Service Advisory

CC-690

Models Affected: **TANK S 6032 D** (53AY8DU6050).
TANK S 7232 D (53AY8DU8050).

Subject: **Mandatory Replacement Of Mule Drive Pulley Spacer 01009604.**

FIGURE 1

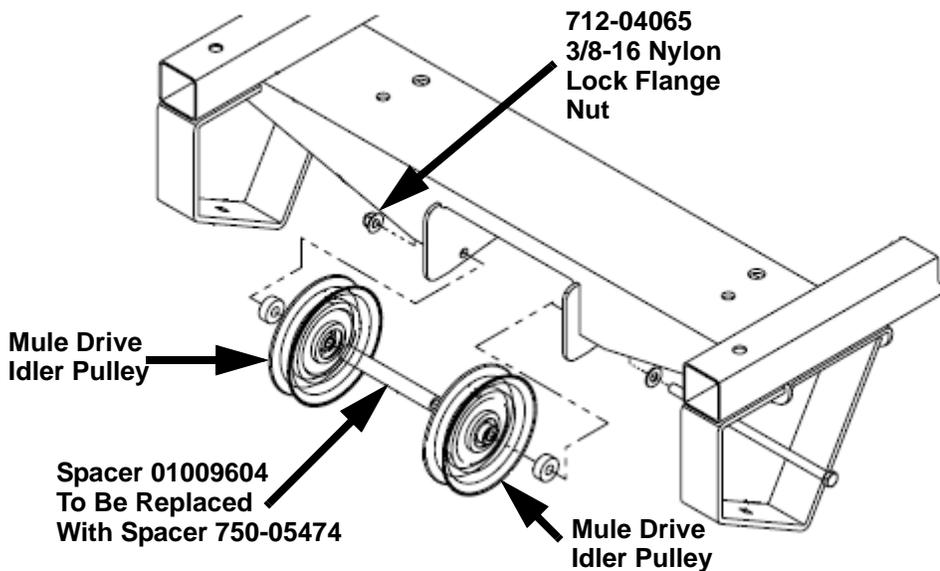
PURPOSE: The diameter of the mule drive pulley spacer is being increased to help maintain the position of the mule drive idler pulleys.

ACTION REQUIRED: Order Qty. one (1) of a 750-05474 spacer and Qty. one (1) of a **712-04065** 3/8-16 nylon lock flange nut. Remove the existing .385 ID x .625 OD x 4.89 LG spacer **01009604** and replace with the .385 ID x .750 OD x 4.89 LG spacer **750-05474** and secure with new 3/8-16 nylon lock flange nut **712-04065**.

FIGURE 4

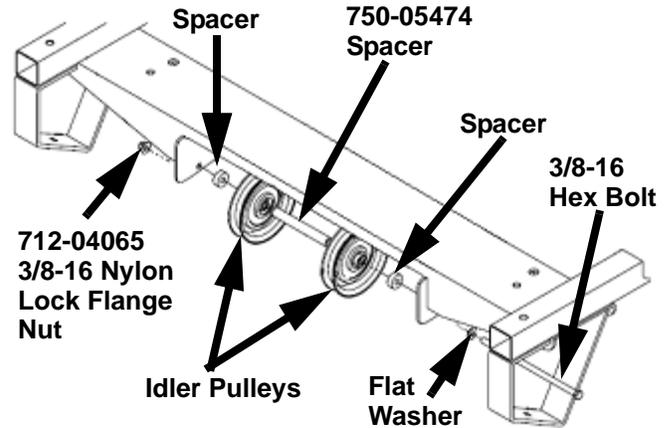
6. Remove the 3/8-16 x 8.50" hex bolt from the mule drive idler pulley assembly. **NOTE: Do not loose the spacers between the idler pulleys and frame mount brackets.**
7. Remove and discard the .385 ID x .625 OD x 4.89 LG spacer **01009604**.
8. Assemble the idler pulleys and spacers as shown in Figure 4 using the new .385 ID x .750 OD x 4.89 LG spacer **750-05474**.

9. Install the new 3/8-16 nylon lock flange nut **712-04065** onto the 3/8-16 hex bolt and tighten securely.
10. Install the P.T.O. belt back onto the P.T.O. clutch and around both mule drive idler pulleys.
11. Make sure the P.T.O. belt is properly routed.
12. Hook the idler arm tension spring back onto the deck anchor bracket using a spring tool.
13. Connect the positive battery cable to the positive battery terminal. Connect the negative battery cable to the negative battery terminal.
14. Start unit and confirm that all safety features are operating correctly.
